Preliminary Assessment Report For Vaughan MTS#1 Station Expansion

CAA ID 2003-89

Final Report

Vaughan MTS#1 – Transformer Addition

Figure 1. Vaughan MTS#1TS Single Line Diagram¹⁰

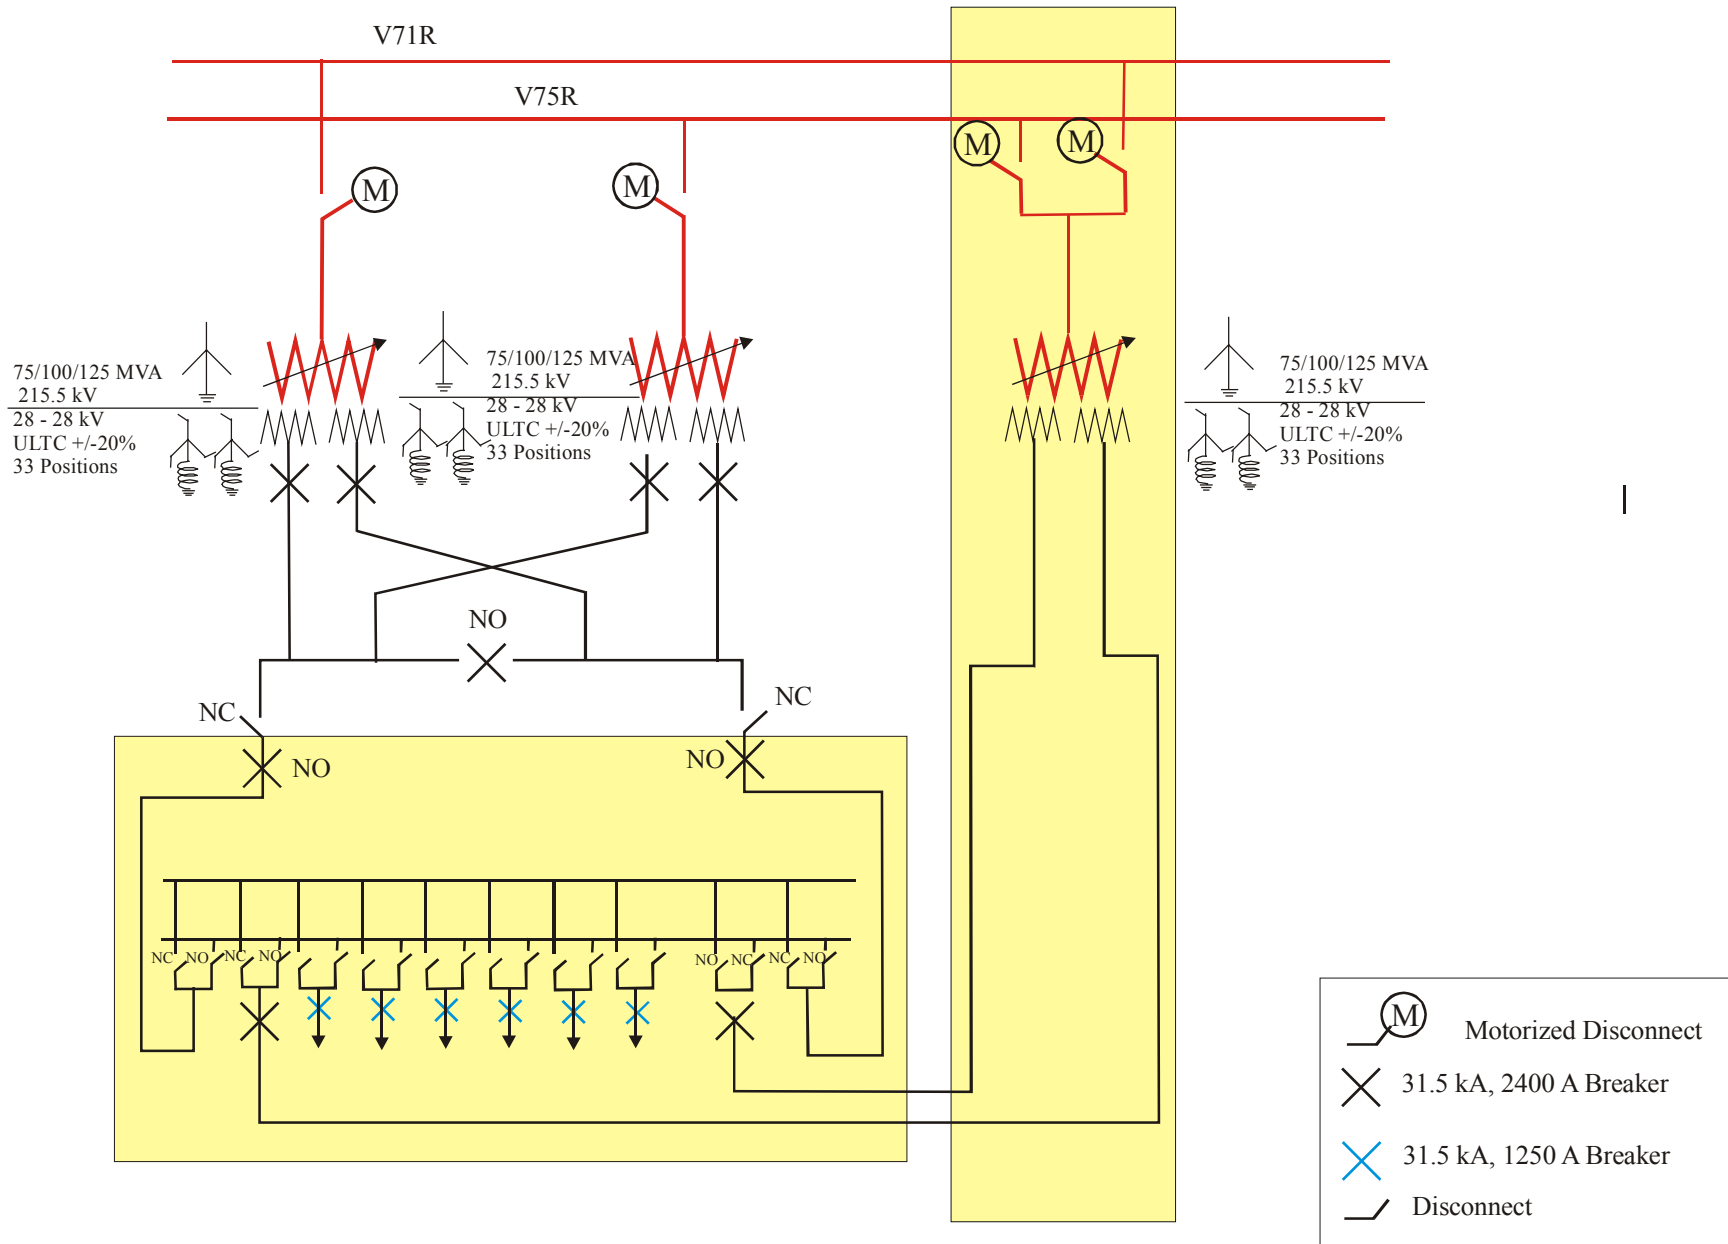
The proposed third transformer at Vaughan MTS#1 is to be connected to the 230 kV circuits V71R and V75R via two motorized disconnect switches which will be equipped with switching logic and interlocks to ensure that the two switches cannot be in closed position simultaneously.

As required by the Transmission System Code, Hydro Vaughan is to provide transfer trip of the Transmitter's breakers at Claireville TS and Richview TS for transformer faults and for failure to operate of the LV breakers. It is also required that the protection system initiate simultaneously both signals for transfer trip and the opening of the HV disconnect switch. Full opening of the disconnect switch shall then block the sending of the transfer trip signal.

Hydro Vaughan is required to confirm that the new HV disconnect switches are capable for continuous operation at 250 kV.

Figure 2. Vaughan MTS#1 New Transformer Location -Claireville Area Transmission -

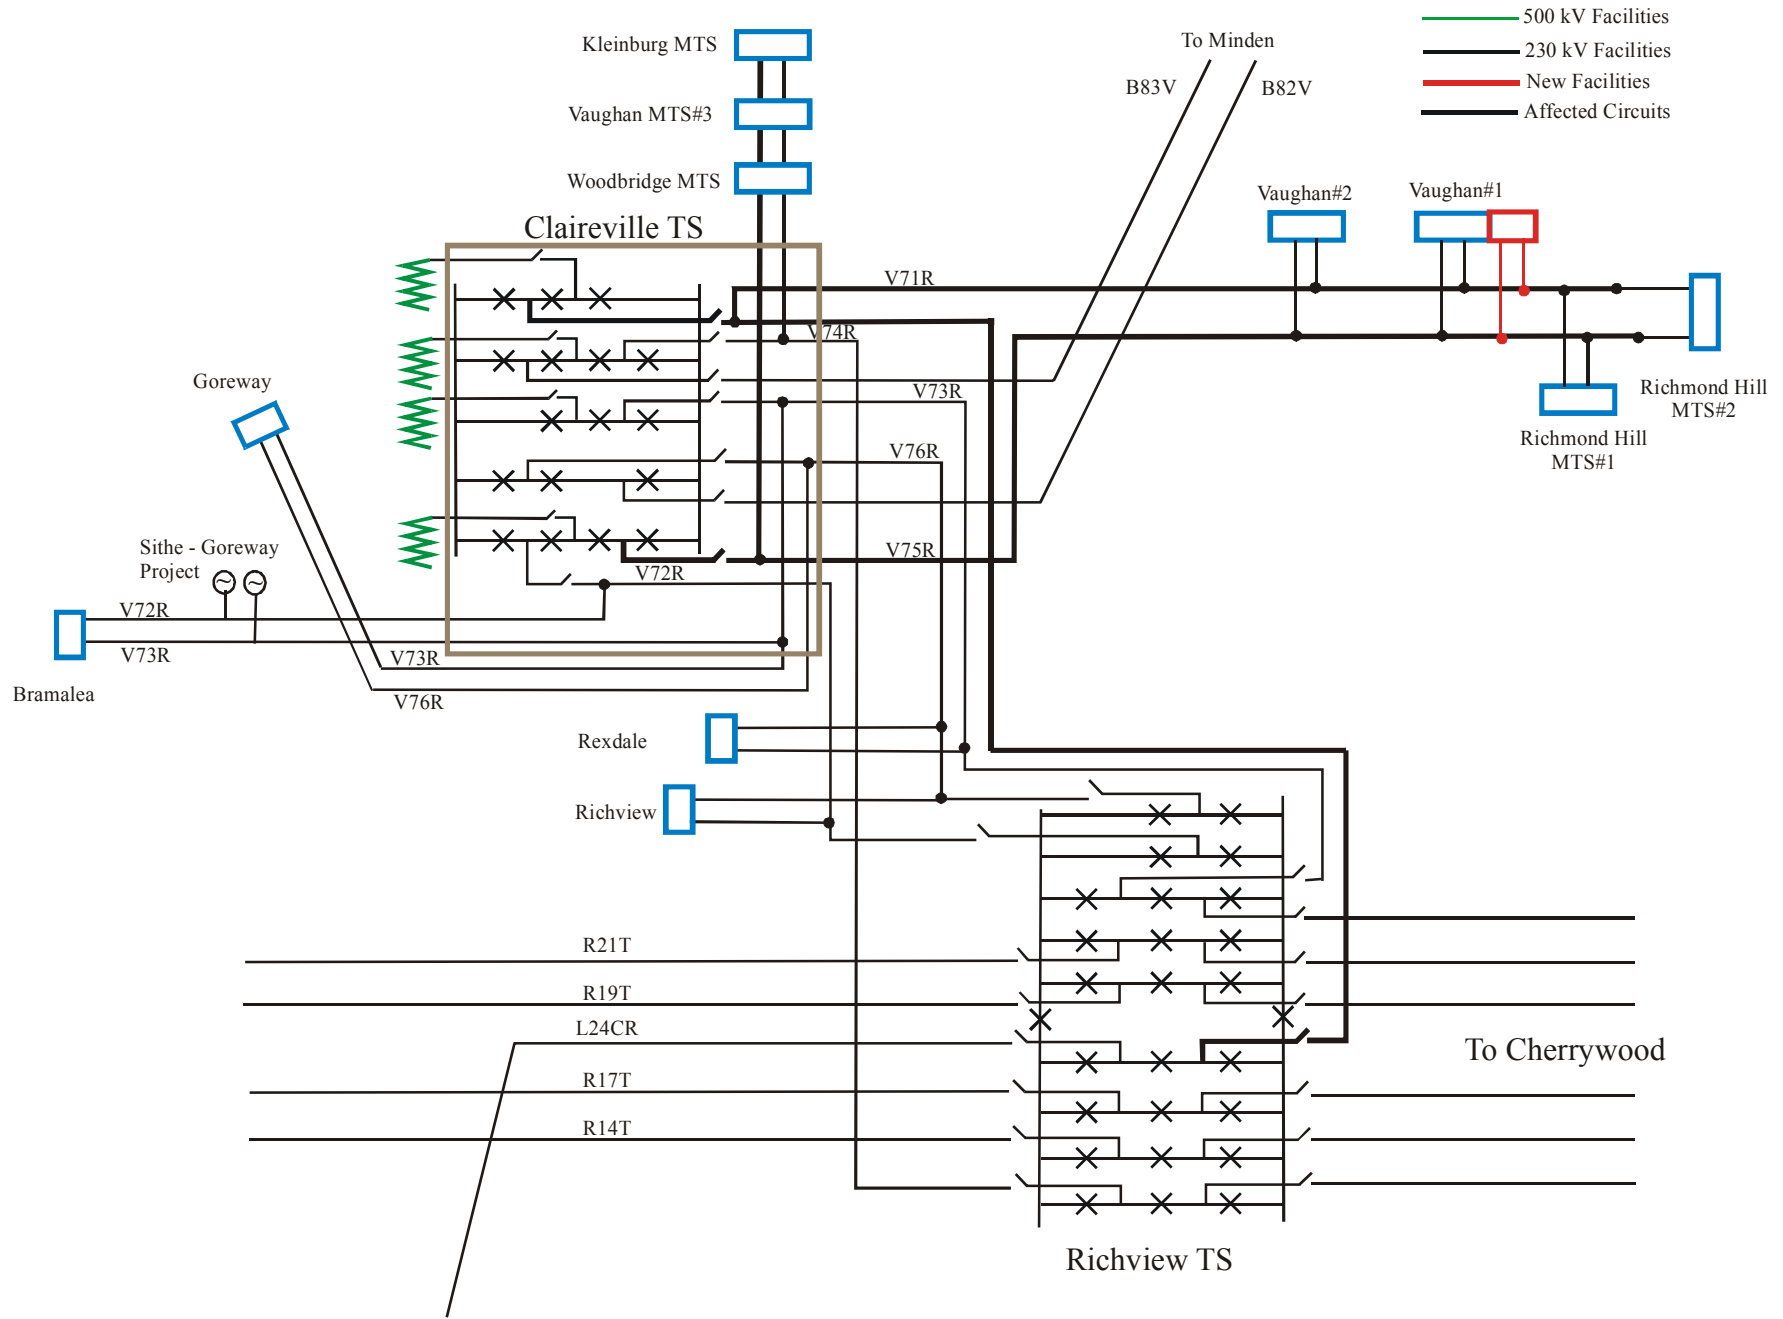
The third transformer at Vaughan MTS#1 will have a dual supply from the 230 kV double-circuit line V71R/V75R. Figure 2 shows a schematic representation of the IMO-controlled Grid in the area surrounding Claireville TS together with the location of the new proposed transformer. Circuit V71R is a three-ended circuit connecting Claireville TS to Richview to and to Richmond Hill MTS#2. The circuit designated as V75R also branches into two sections one terminating at Kleinburg TS and the other one at Richmond Hill MTS#2.

The study results confirmed that, with the existing LV shunt capacitors in service, the loss of one of the 230 kV circuits supplying these stations could result in the overloading of the remaining circuit. It was observed that due to the heavy MW loading of these two circuits the reactive power flows are also very high. After the loss of one of the two circuits the Mvar consumption over the remaining circuit could become extremely high resulting in power flows that are over the MVA circuit's capacity. This problem could be partly alleviated by reducing the reactive power flow over the V71R/V75R transmission corridor. This could be achieved by the installation of low voltage shunt capacitors at the three municipal transformer stations that do not presently have LV reactive support.

The results of this analysis indicated that by summer 2006, the emergency rating of the 230 kV circuits would be exceeded by 13% under contingency situations. In this case low voltage shunt capacitors would need to be installed before 2006 to reduce the power flow close to, but slightly above the emergency rating of the 230 kV circuits.

One additional 21.6MVA_r shunt capacitor bank is required to be installed at Vaughan MTS No. 1 as part of the proposed expansion of this station.

Vaughan Hydro and Richmond Hill Hydro are required to install sufficient shunt capacitor banks at the remaining MTSs associated with circuits V71R & V75R to ensure compliance with the requirements of the Market Rules with respect to the power factor at the defined meter point.

In the event that all of the additional capacitor banks that have been 'proposed' are not installed, the IMO will require a temporary load rejection scheme to be installed to address possible overloading of circuits V71R & V75R until Parkway TS is established and circuits V71R & V75R are extended and terminated on to the new 230kV station.
